Our Ref: CD/FSSD/12/02/03/01

AMENDMENTS TO FIRE CODE 2018 - 9th BATCH OF AMENDMENTS

SCDF would like to issue the 9th batch of amendments to the Code of Practice for Fire Precautions in Buildings 2018 (Fire Code 2018). The amendments which were deliberated and accepted by the Fire Code Review Committee are attached as Annex A & Annex B of this circular.

Diagram 4.2.2e. : Turning facilities for firefighting appliances

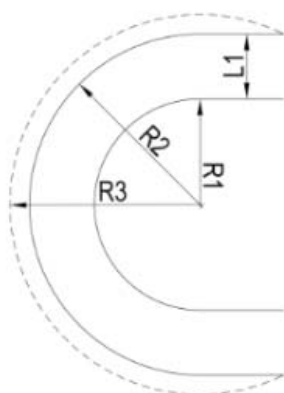
Dimensions of Turning Facilities for Firefighting Appliances			
Parameters	Building Habitable Height		
	$\leq 10\text{m}^*$	$> 10\text{m} \ \& \ \leq 50\text{m}^\#$	$> 50\text{m}^\#$
R1	4.0m	6.5m	7.5m
R2	8.0m	10.5m	12.0m
R3	8.5m	12.0m	14.8m
L1	4.0m	4.0m	4.5m
L2	11.0m	16.0m	21.0m
L3	15.0m	28.1m	33.5m
L4	8.0m	10.5m	12.0m

* - These dimensions are applicable to all PG except PG VI and VIII buildings, unless otherwise stated in *Cl.4.2.2a.(1)*. For PG VI and VIII buildings $\leq 10\text{m}$, it shall refer to ($> 10 \ \& \ \leq 50$) requirements (as indicated in *Table 4.2C*).

- Not applicable to PG I buildings. For PG I buildings, it shall refer to ($\leq 10\text{m}$) requirements.
